Memorandum –Response to Parks

To: Charlotte Macdonald – Barker & Associates
From: Terra Studio
Re: A Memorandum Responding to the Park Pre-App meeting

This memorandum responds to items outlined in Barker and Associates meeting minutes, dated 19 November 2025, relating to the design and compliance of the two proposed parks in Delmore.

Figure 3 – Stage 2 park amended slightly since the initial application to suit the new collector road width and roundabout.

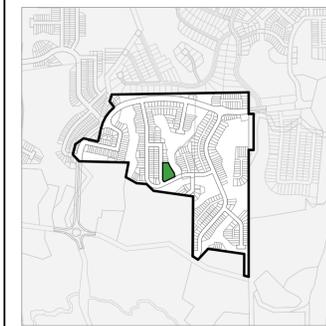
At the pre-app meeting on 19 November 2025, the potential use of a 1m high retaining wall around the park perimeter was discussed to increase the area of land with a 3% gradient. Following detailed design investigations, the applicant determined that a wall in this location would require substantial structural engineering due to surcharge from the houses and 1:3 slopes above, as well as the instability from the 1:3 batter slope below. Although the wall would appear to be only 1m high, its rake, structural thickness, and required embedment depth would outweigh the potential benefits.

The location and boundaries of the Stage 2 park were slightly amended to suit the new collector road and roundabout that were introduced for the second Delmore lodgment, however the fundamental design and levels remain largely unchanged. The northern boundary of the park now interfaces the proposed commercial area, with pedestrian access between the two requiring some stairs.

Figure 3 below highlights the park design which has been amended from the initial application and its interface with the commercial area.

Figure 1 - Stage 1 park with an additional 750m² of 3% max. gradients outside of the 30x30 kickball area highlighted in blue

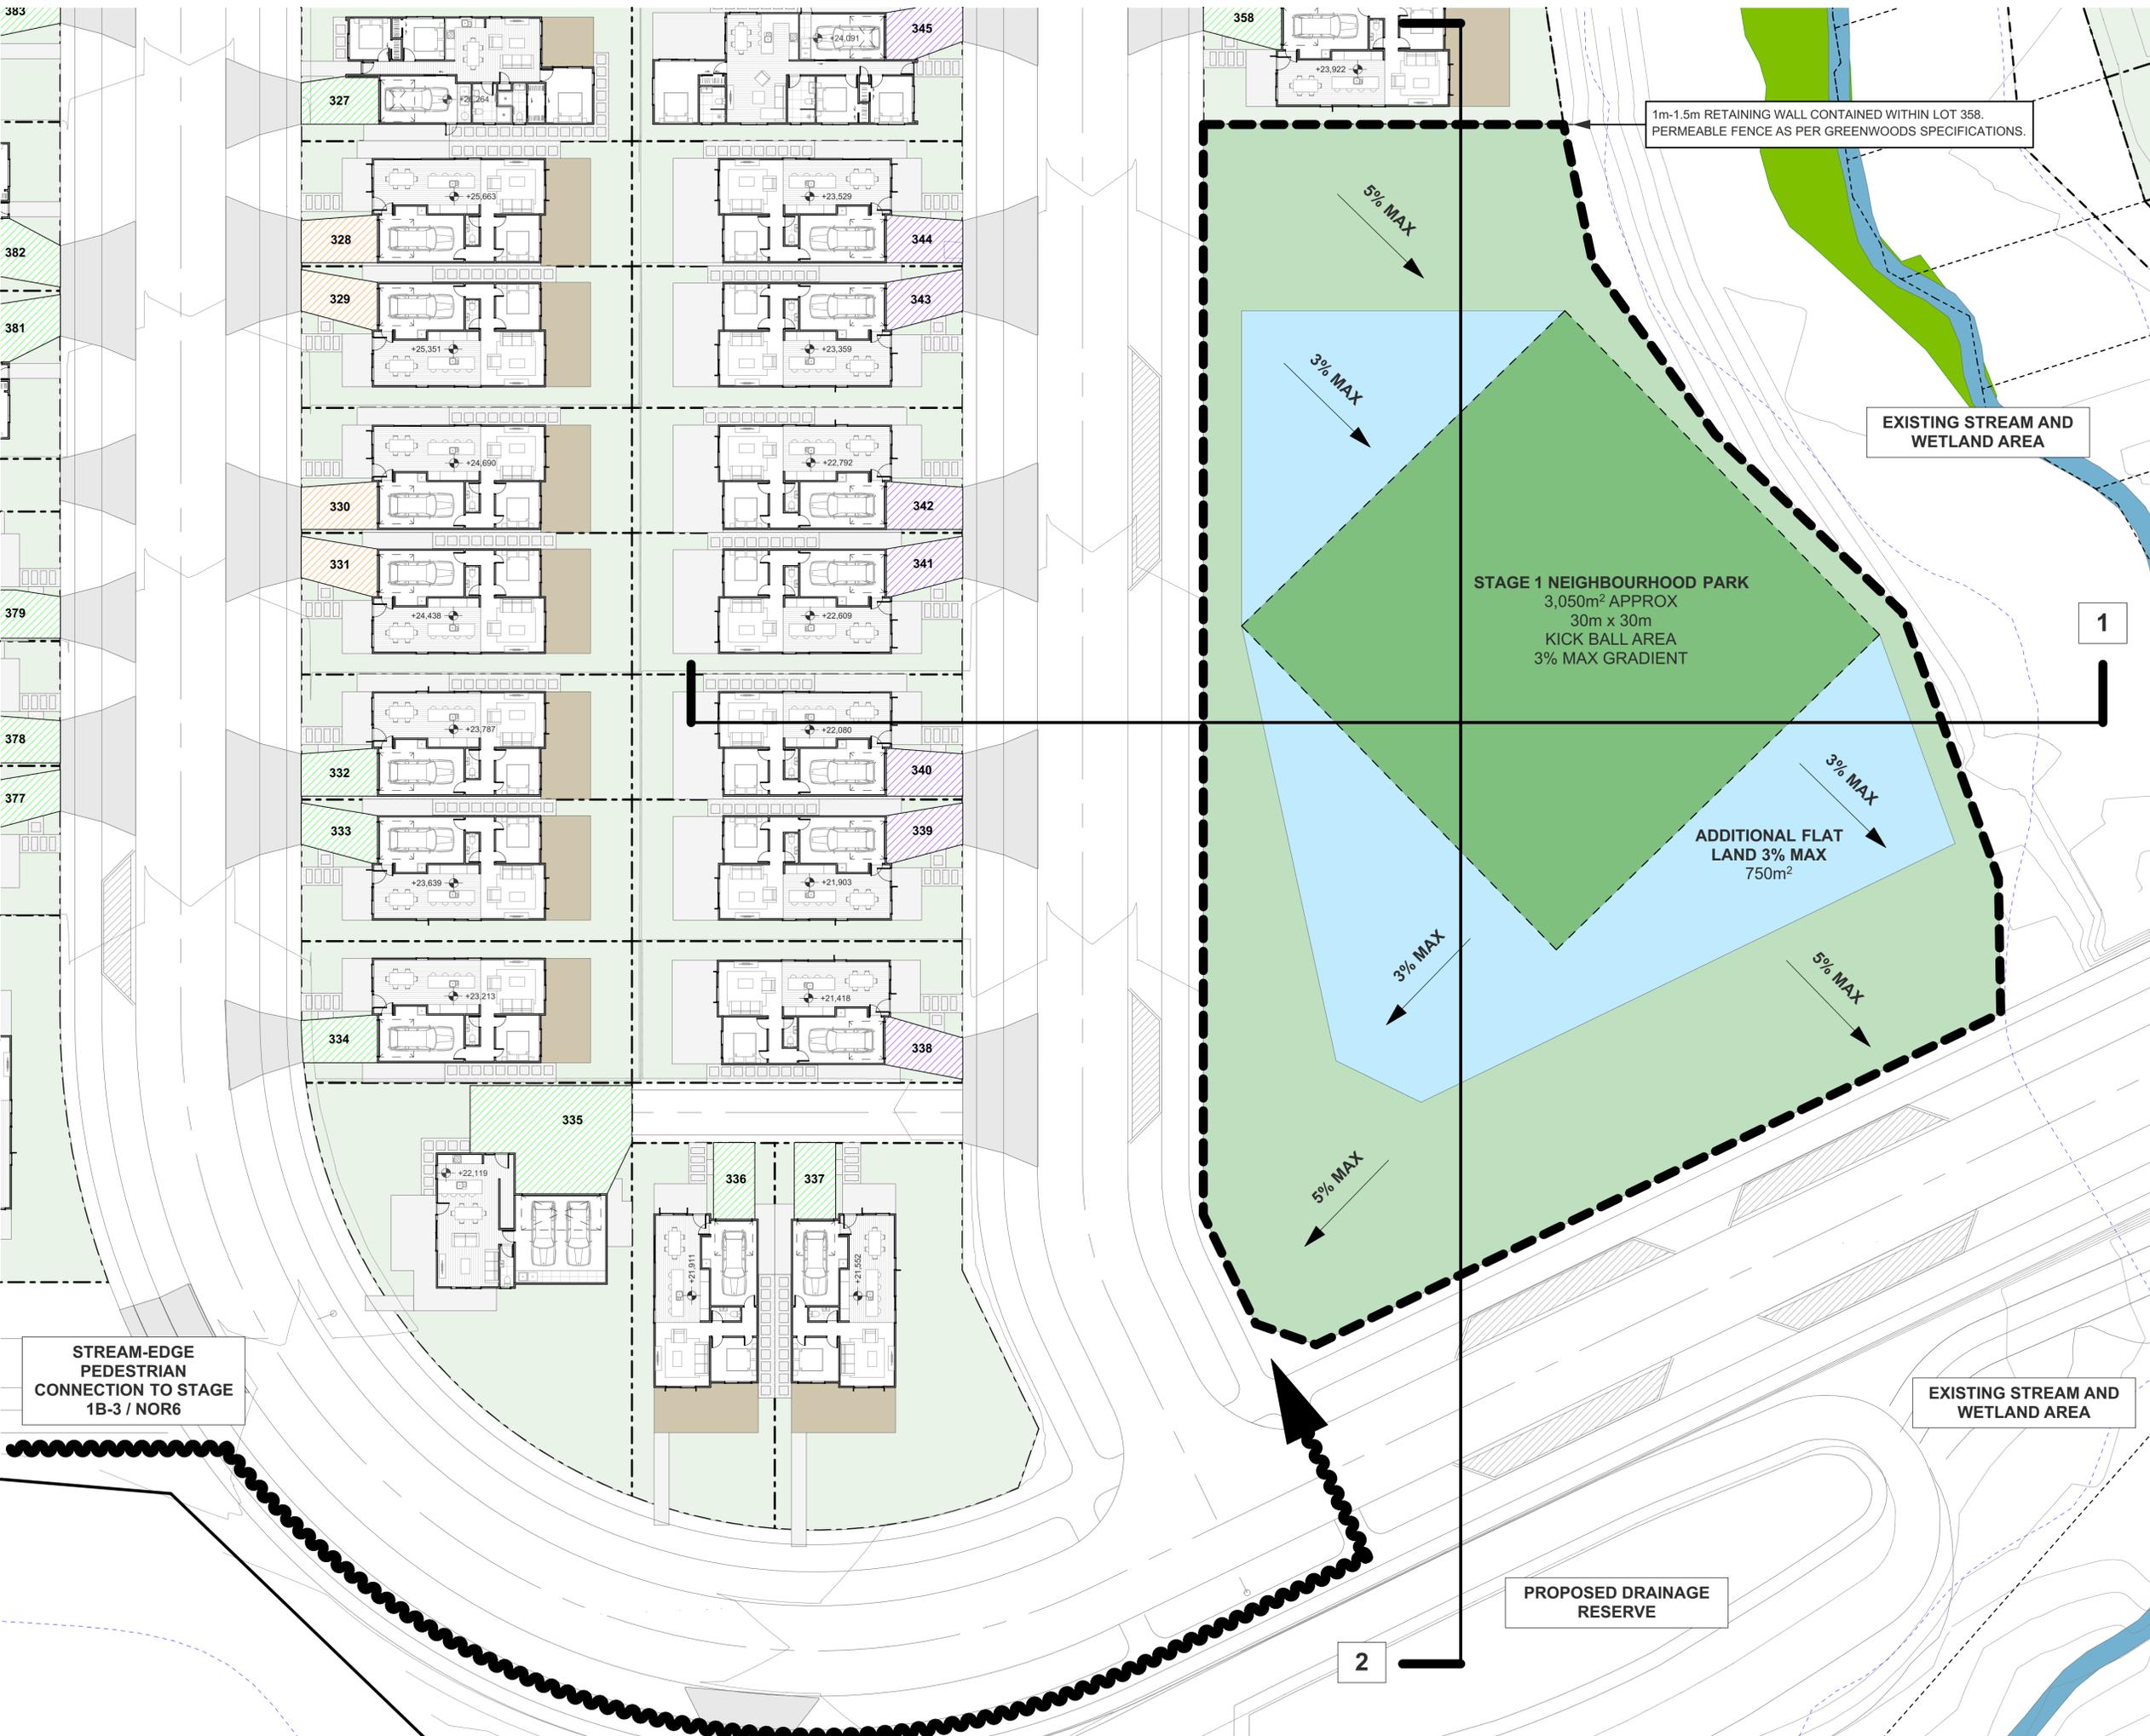
- At this meeting, Parks supported the Stage 2 park design, and largely supported the Stage 1 park design, but requested refinement to the areas outside of the 30x30 kickball area by increasing the provision of land graded at 3% to enhance activation and provide further useable land exceeding compliance.

The location, size and boundaries of the Stage 1 park remain as per the previous substantive application, with further refinements made to the areas outside of the 30x30 kickball area, providing additional flat land not exceeding 3%. Figure 1 below highlights the additional 750m² area in blue.
